BURLINGTON DEVELOPMENT REVIEW BOARD Tuesday November 20th, 2018, 5:00 PM Contois Auditorium, City Hall, 149 Church St, Burlington, VT AGENDA

1. 19-0326CA; 121 Crescent Beach Drive AND 19-0367CA; 133 Crescent Beach Drive (RL-W, Ward 4N) Crescent Beach Drive Association

2. 19-0355CA; 441 Shelburne St (RM, Ward 5S) 441 Shelburne Road, LLC

RICHARDSON MULTIFAMILY HOUSING

Sheet Title: **Site Plan**
 Project Title: **435/441 Shelburne Street Multi-Family**
 Burlington, Vermont

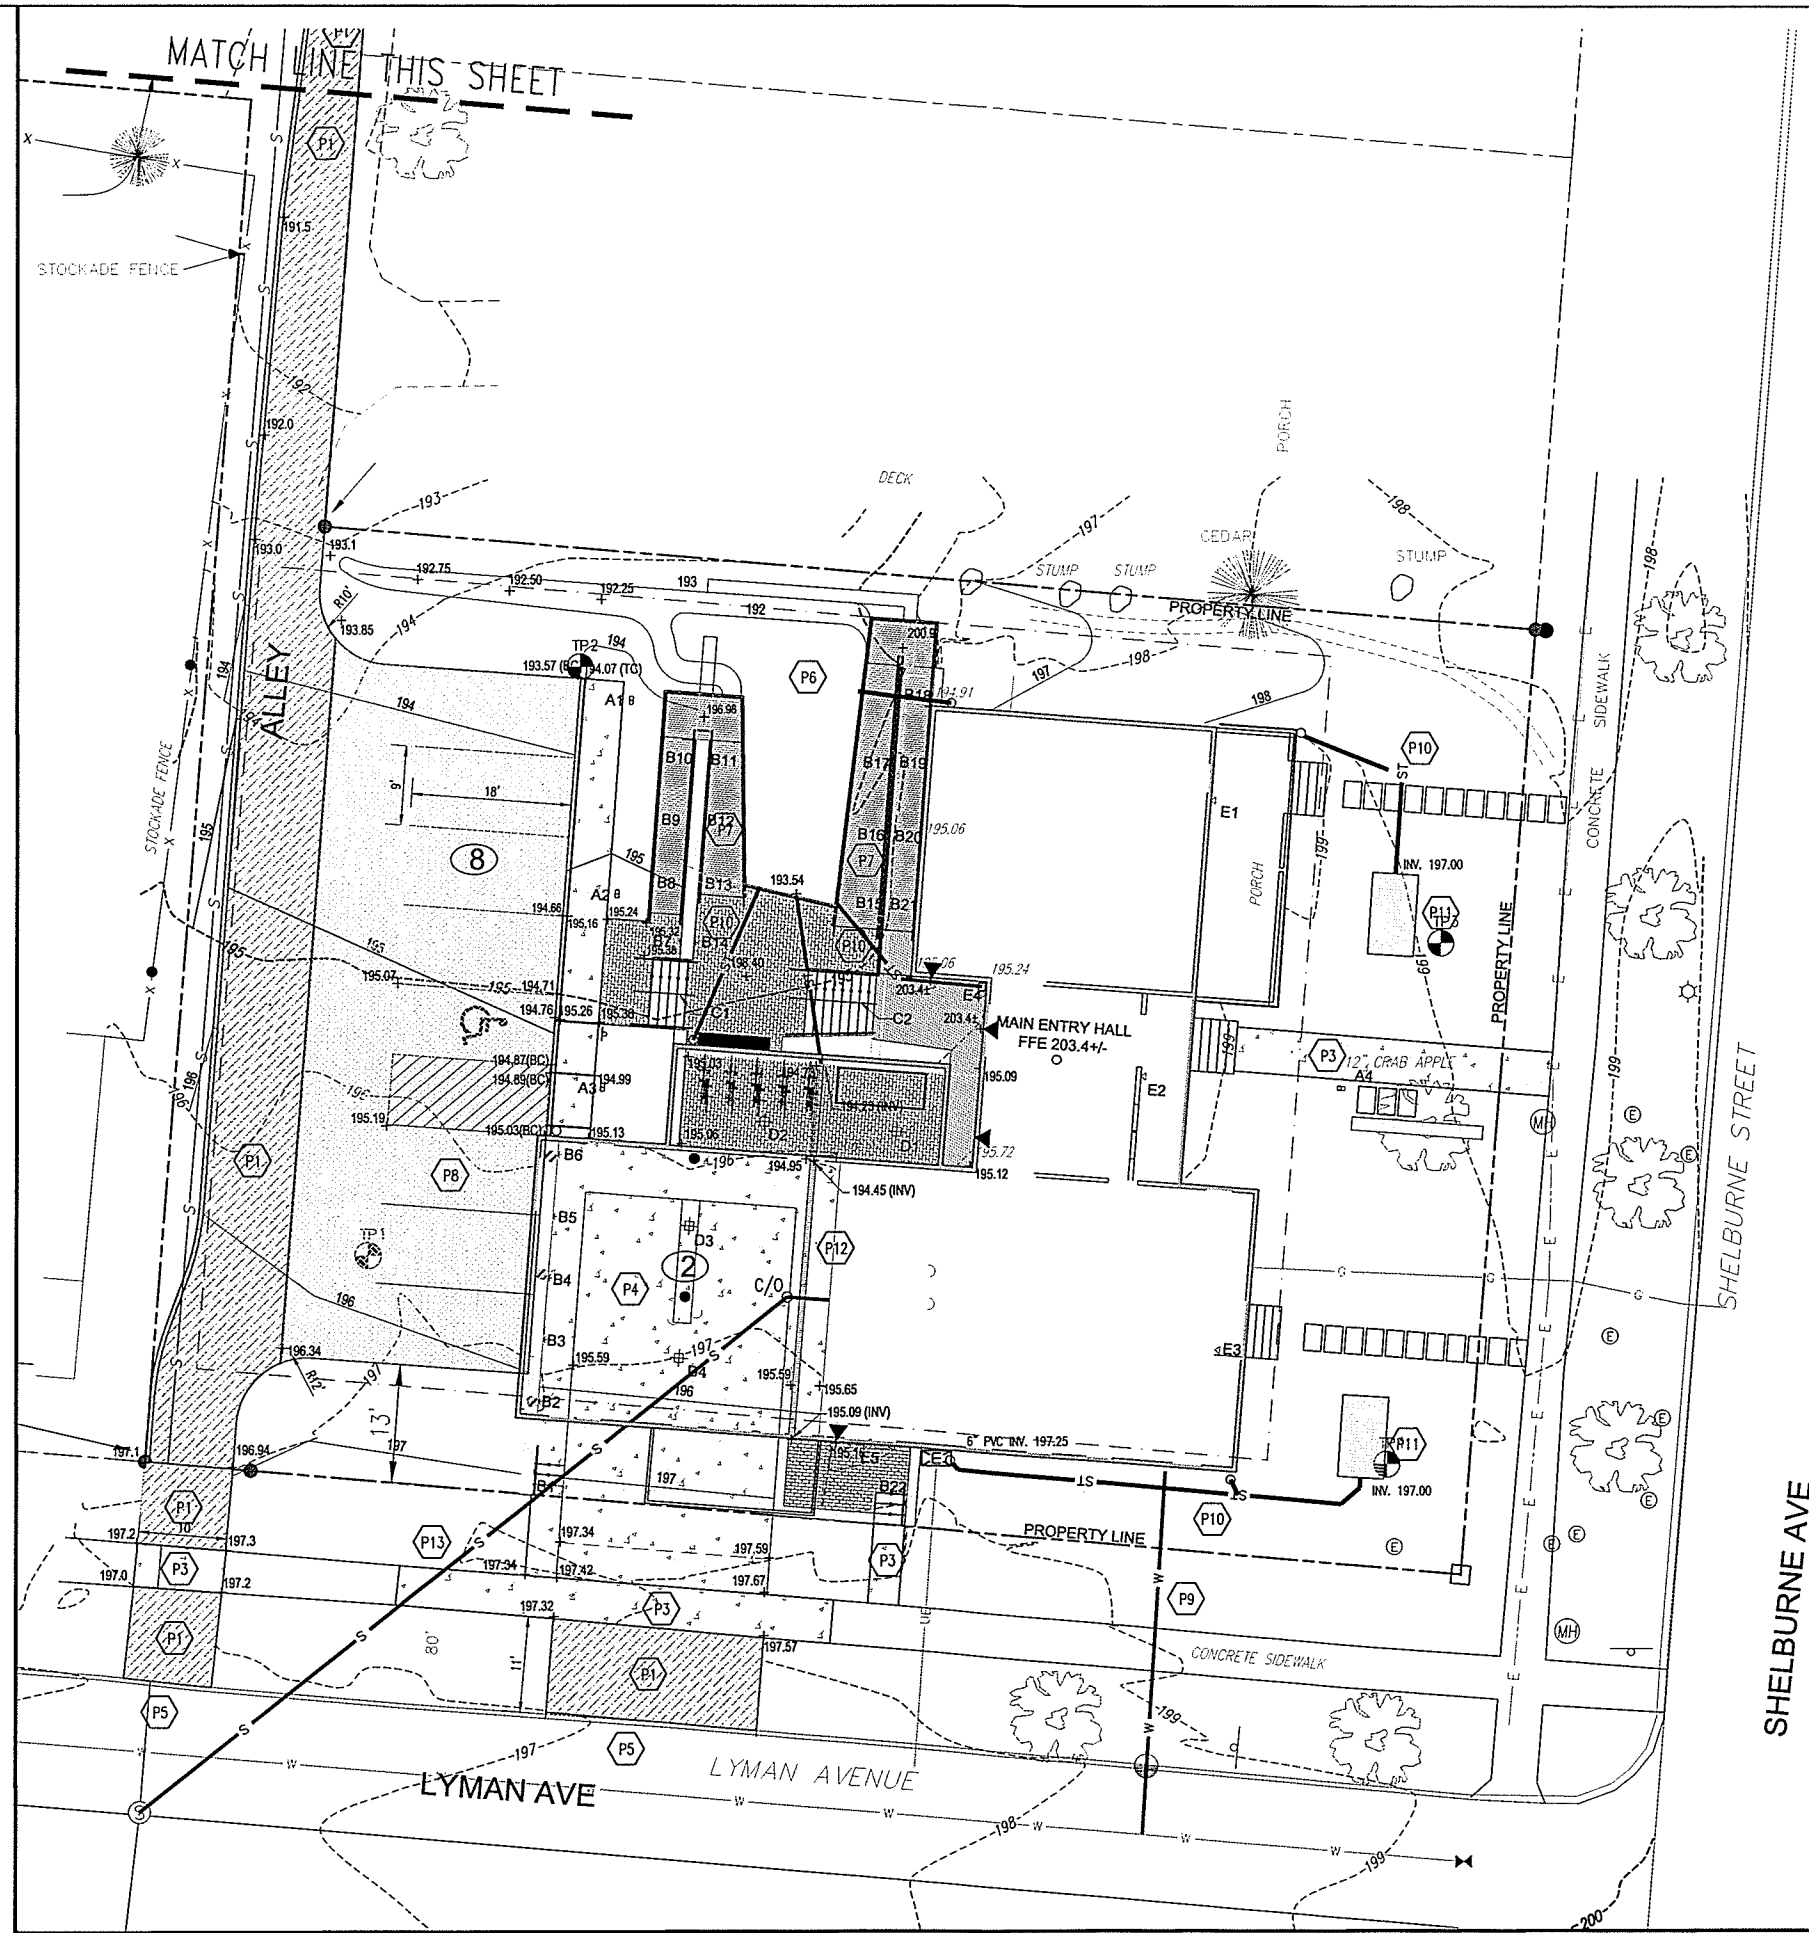
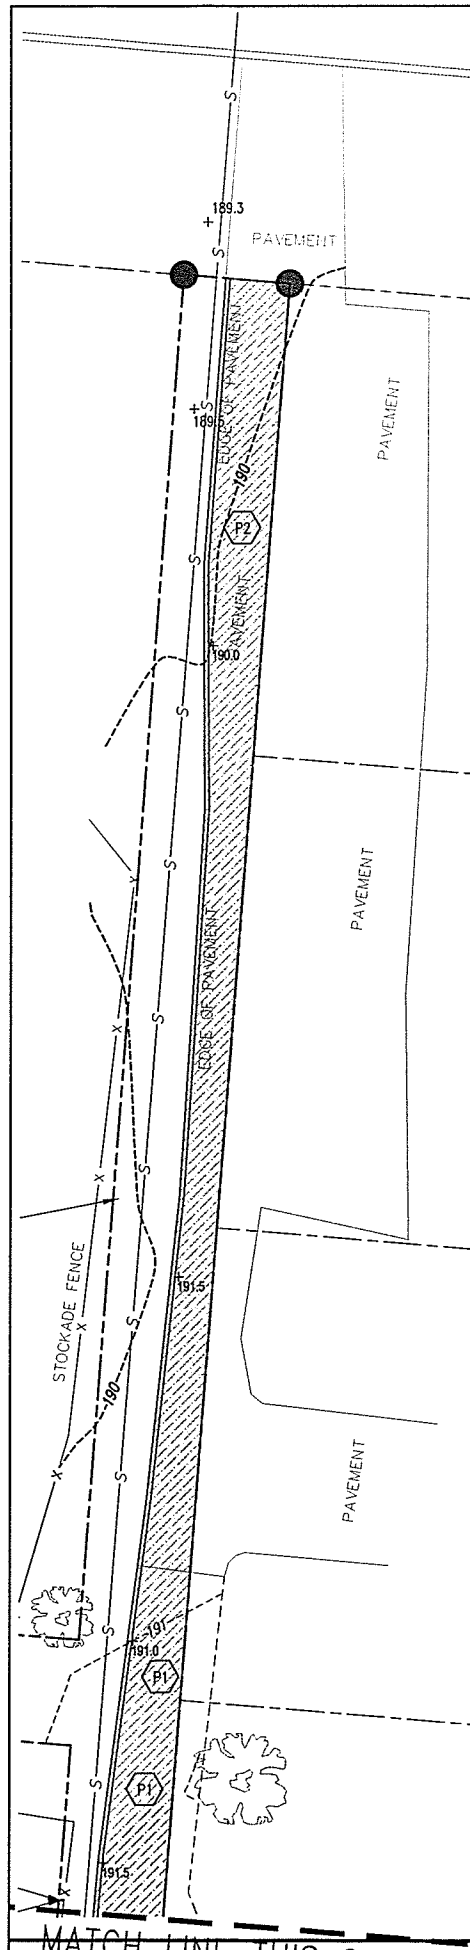
ADA parking and related ramps are depicted on the site plan. It is the applicant's responsibility to comply with all applicable ADA requirements as administered through the building code.

The site plans depict one handicap parking space in close proximity to a walkway connecting to a building entrance. Associated striping is also shown. ADA compliance is administered via the city’s building permit process. **(Affirmative finding as conditioned)**

Sheet Title: **Erosion Prevention and Sediment Control Plan**
Project Title: **435/441 Shelburne Street Multi-Family**
Burlington, Vermont

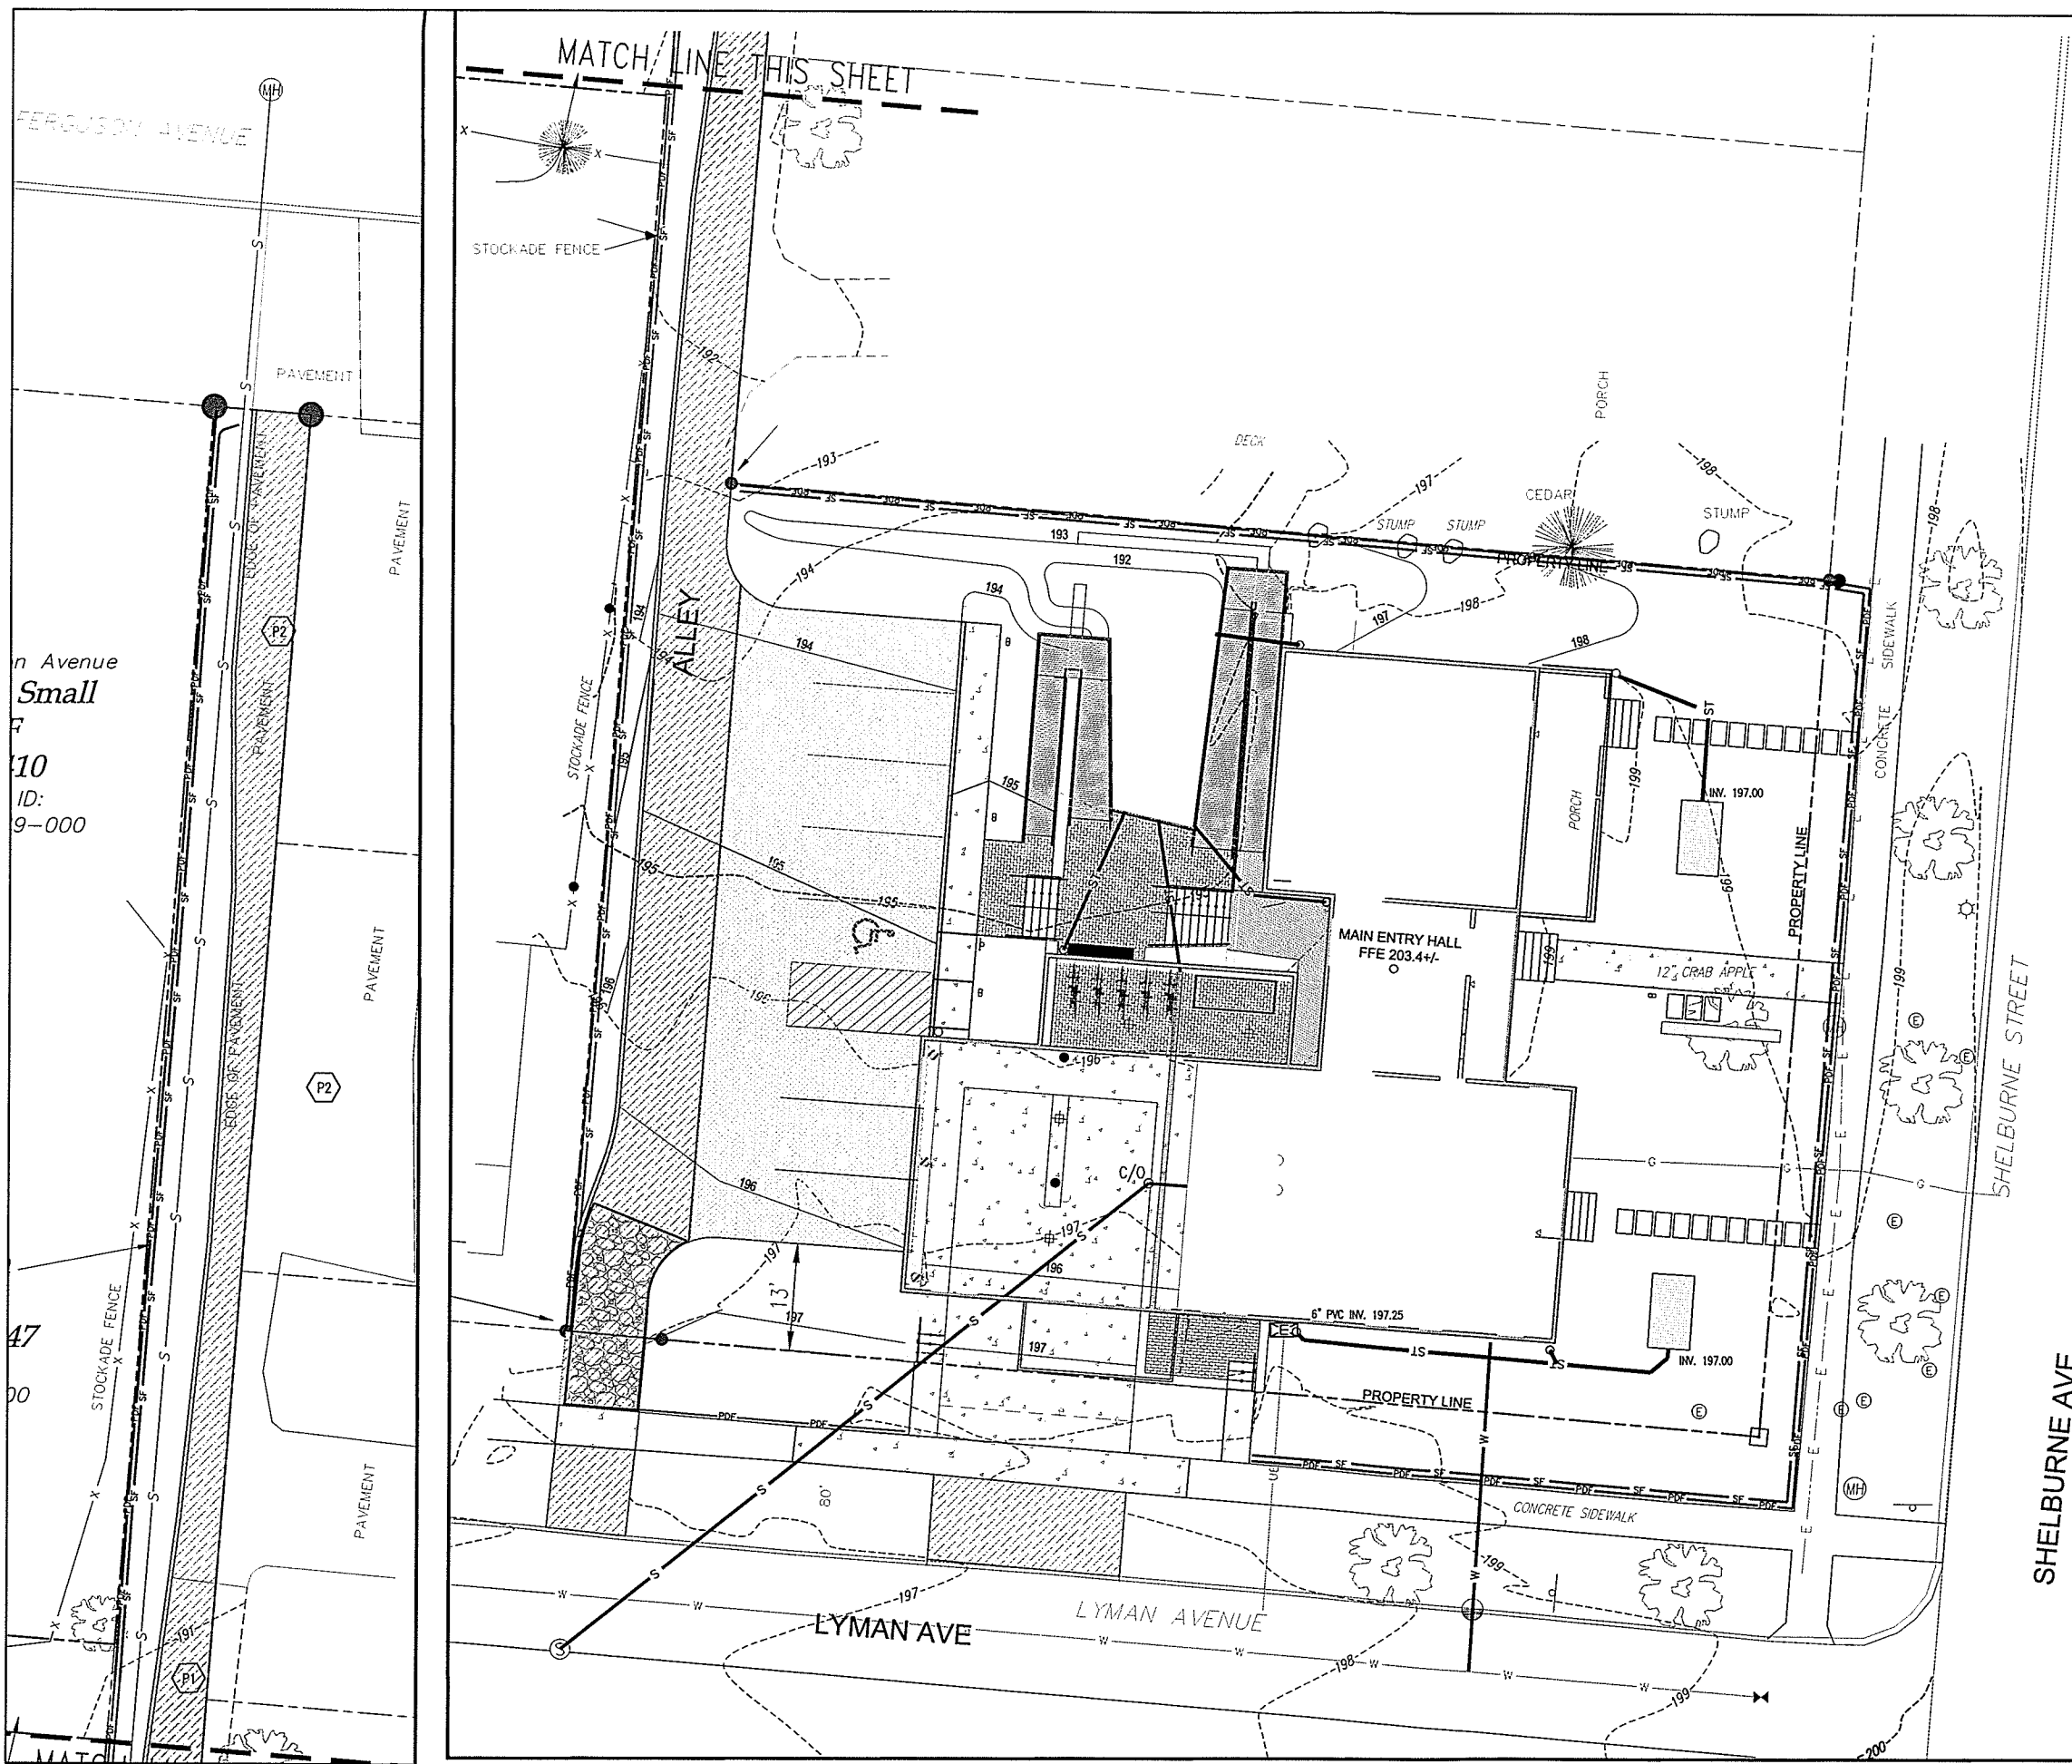
The applicant has submitted an Erosion Prevention and Sedimentation Control Plan (EPSC) for the project which is currently under review by the Stormwater Program Manager. Before the zoning permit can be released, the EPSC must be approved. **Affirmative finding as conditioned**
